**WHITE PAPER No. 5C – EVALUATION OF REMEDIAL ALTERNATIVES FOR
LITTLE LAKE BUTTE DES MORTS
PROPOSED BY WTMI AND P.H. GLATFELTER**

Response to a Document by CH2M HILL

**FOCUSED FEASIBILITY STUDY FOR OPERABLE UNIT 1
LOWER FOX RIVER SITE**

This Document has been Prepared by
Wisconsin Department of Natural Resources

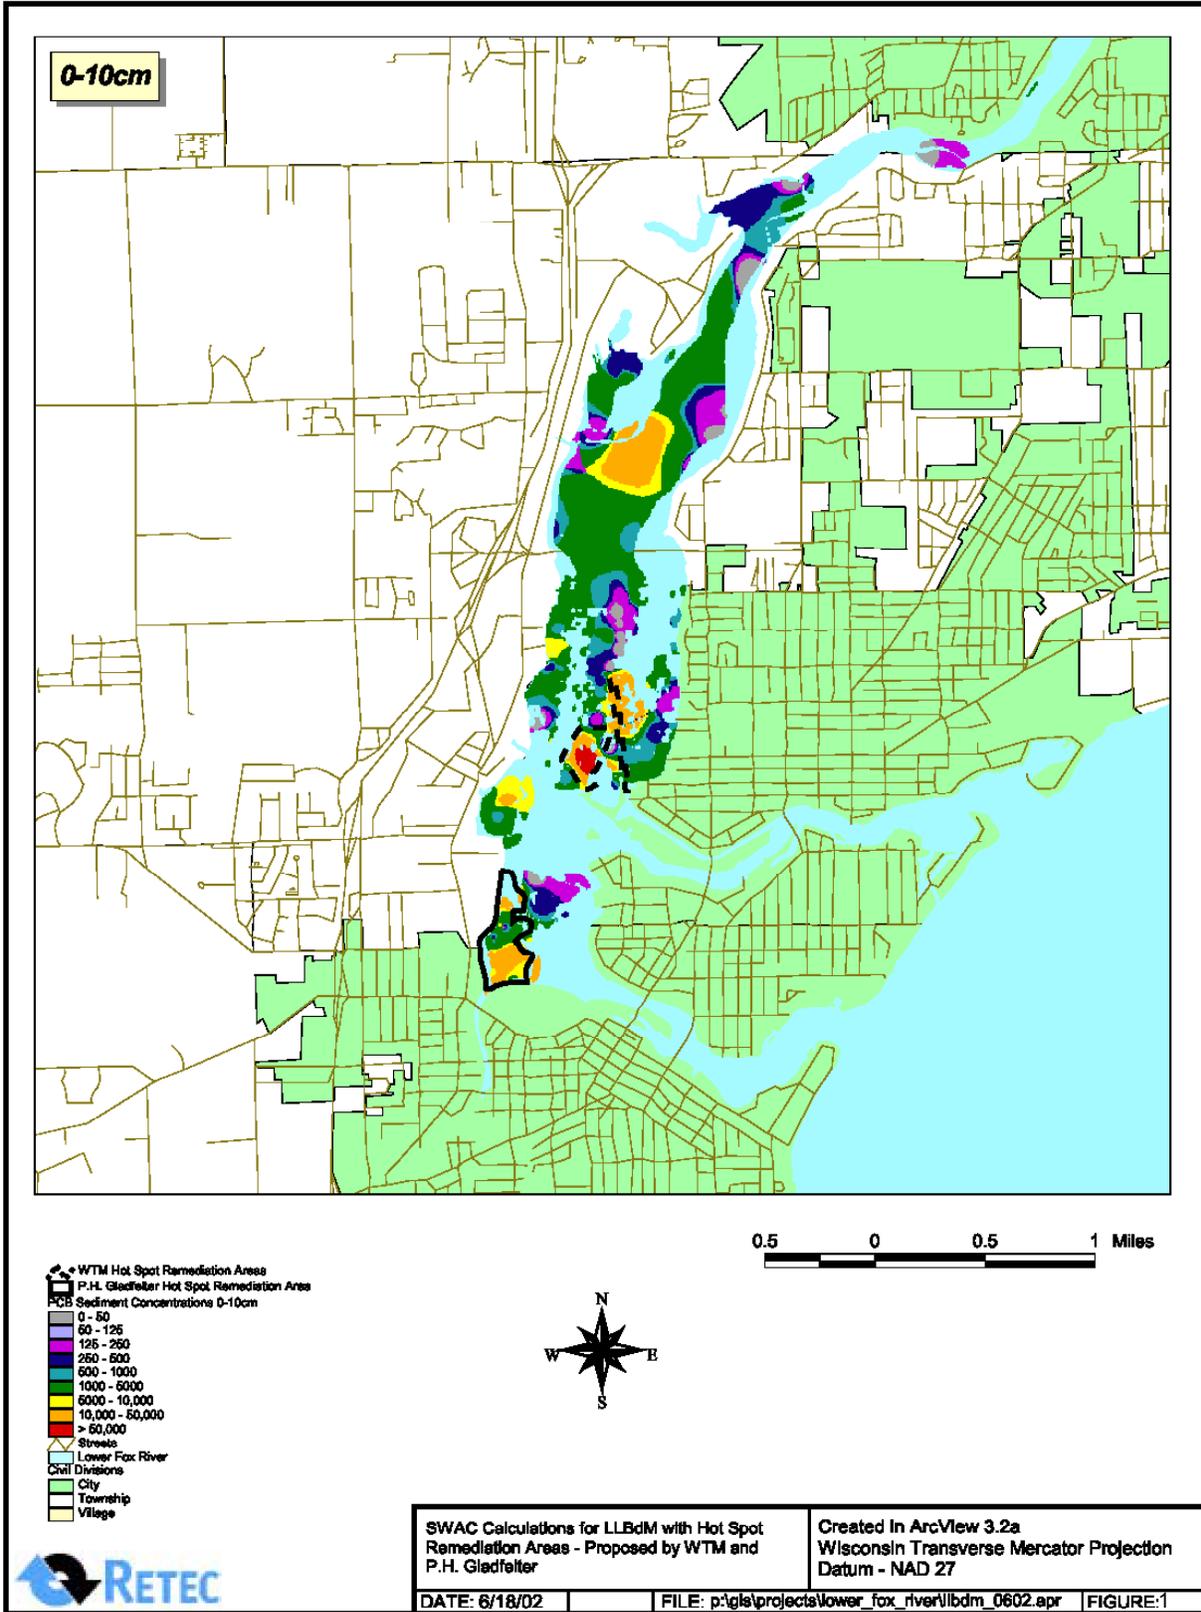
Methods for recalculating the SWAC are defined in *White Paper No. 5A – Responses to the API Panel Report* (WDNR, 2002b). The three remediation areas proposed by WTMI and PHG include Deposit A, the southwestern area in Deposit POG, and the northern portion of the navigation channel in Deposit POG (Figure 1). These three proposed remediation areas were digitized from the figures presented in the two reports, and imported into ArcView GIS software. Upon overlaying the digitized remediation areas on the interpolated PCB concentration maps, adjustments were made as needed to the location of the areas to the best extent possible to match the remediation areas specified by WTMI and PHG. Upon overlaying the WTMI-proposed remediation areas on the interpolated PCB concentration map, SWAC calculations were completed.

Table 1 compares the Proposed Plan SWAC at the 1 mg/kg RAL with those proposed by the API and by WTMI/PHG. Those SWACs are 0.19, 0.71, and 1.7 mg/kg, respectively. The WTMI/PHG remedial proposal results in a risk level that is twice that proposed by the API Panel, and an order of magnitude greater than at presented in the Proposed Plan. Essentially, the WTMI/PHG proposes an RAL of greater than 10 mg/kg to achieve a SWAC of 1.7 mg/kg.
